Access Compliance Report

Public Rights-of-Way

Intersection ID: 31304	Main Street: WESTBEND_DR	Cross Street: ALEXANDER_POINTE_DR	Location: SE
ADA ID: 6CEB8525F78E	Ramp Type: PerpDiag	Initial Pass/Fail: Fail	Overall Compliance: No
		Severity Score: 22.5

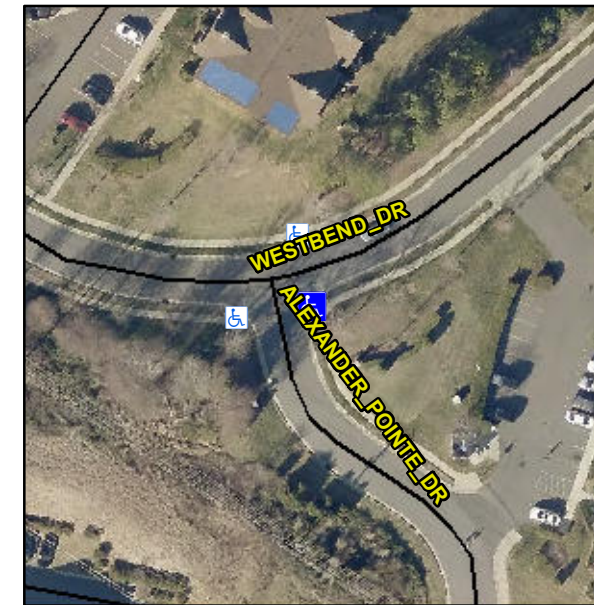
R304.5.1, R304.2.2, R304.5.3

Compliance	Description	Data	Compliance	Description	Data
N/A	Ramp Length (in)	49.0	No	Ramp Slope (%)	8.9
No	Ramp Width (in)	36.0	No	Ramp XSlope (%)	5.0
N/A	Flare Type LT	N/A	N/A	Flare Type RT	N/A
N/A	Flare Slope LT (%)	N/A	N/A	Flare Slope RT (%)	N/A
N/A	Flare Traversable LT?	N/A	N/A	Flare Traversable RT?	N/A
N/A	Landing Length (in)	N/A	N/A	DWS Provided?	N/A
N/A	Landing Width (in)	N/A	N/A	DWS Contrast?	N/A
N/A	Landing Slope (%)	N/A	N/A	DWS Length (in)	N/A
N/A	Landing X Slope (%)	N/A	N/A	DWS Full Width?	N/A
N/A	Landing Curb? (Y/N)	N/A	N/A	DWS Offset (in)	N/A
N/A	Shared Landing?	N/A			
N/A	Gutter Ponding?	N/A	N/A	Gutter Slope (%)	N/A
N/A	Gutter Lip Ht (in)	N/A	N/A	Gutter X Slope (%)	N/A
N/A	Painted X Walk1?	No	N/A	Painted X Walk2?	No
	X Walk 1 Direction	To N		X Walk 2 Direction	To W
N/A	X Walk 1 Width (in)	N/A	N/A	X Walk 2 Width (in)	N/A
	X Walk 1 Slope (%)	5.5		X Walk 2 Slope (%)	8.4
	X Walk 1 X Slope (%)	5.7		X Walk 2 X Slope (%)	2.9

Remove & Replace Curb Ramp With Two New Directional Ramps or Equivalent.
